To All Lamborghini Dealers and Licensed Service Point  
From Customer Service Department  
Subject Anticorrosion screws replacement  
Group LB714.8.07  
Date 17.01.2008  
Pages 4

Anticorrosion screws replacement.

All Gallardo (Coupè, Spyder and Superleggera) from VIN G75155 to VIN G86483.

Pict.1

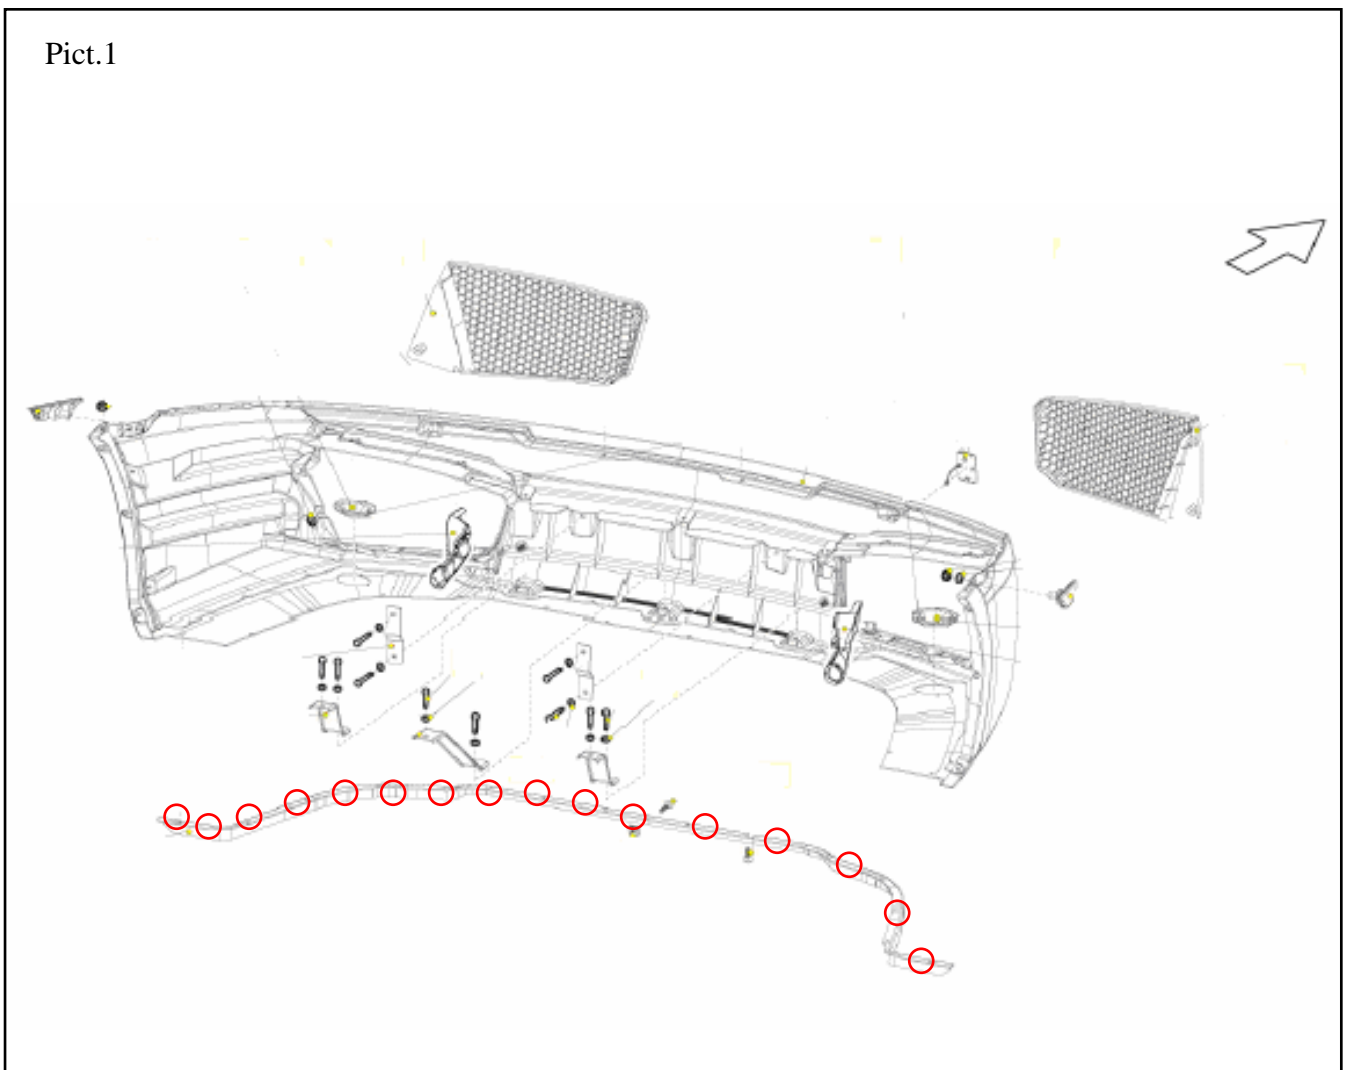
- 1.1 Adopt all precautions to work safe and prevent car damages.
- 1.2 Remove the 17 screws on the front bumper and put the new ones screws (tightening torque 9Nm), as shown in picture 1.

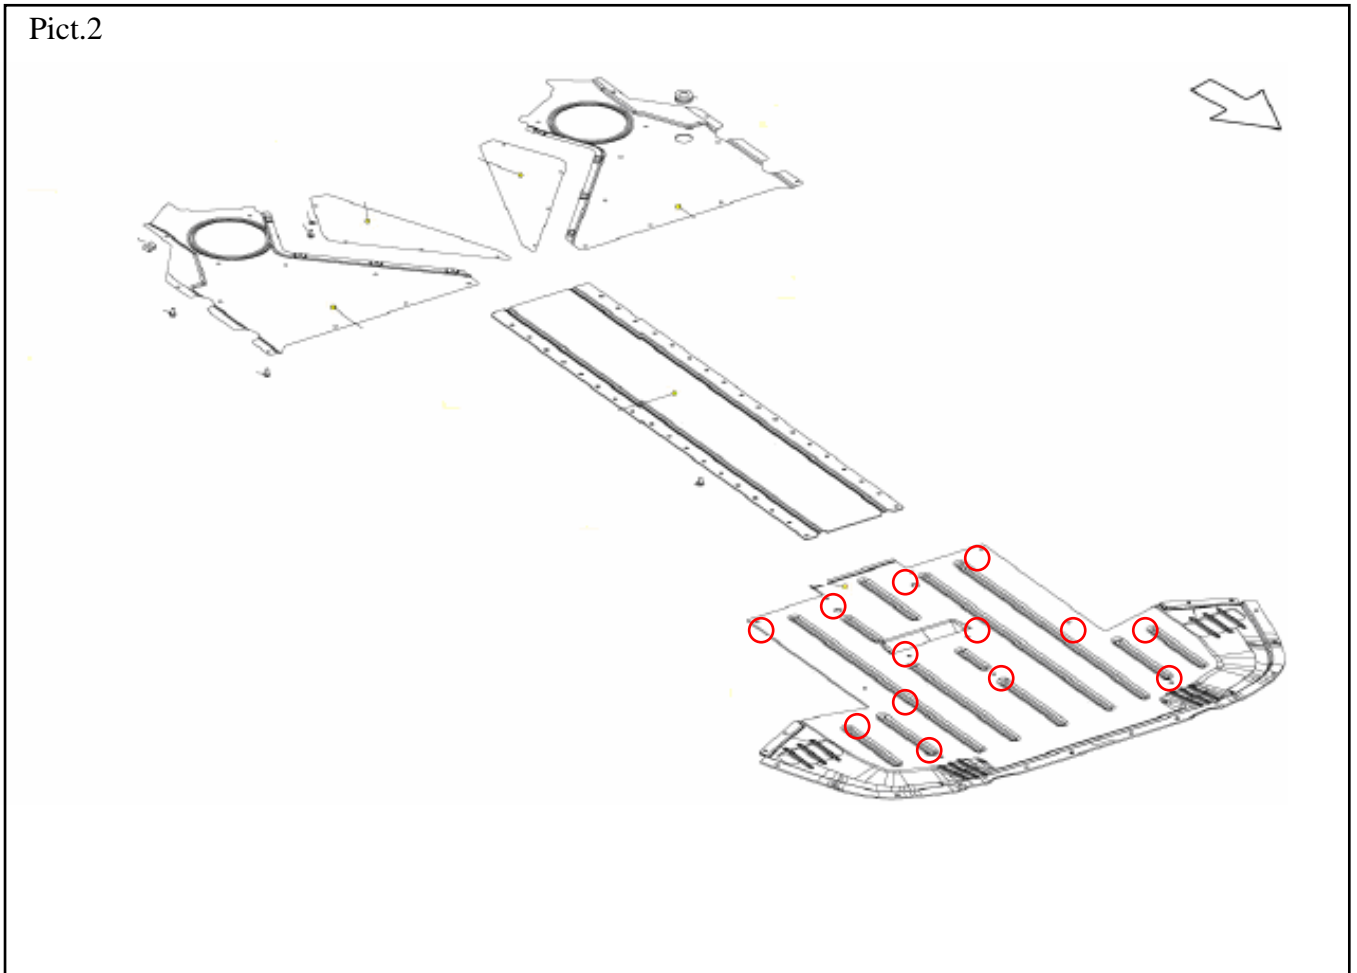
**1.3** Remove the 13 screws in the frame floor panel and put new ones screws (tightening torque 9Nm), as shown in picture 2.
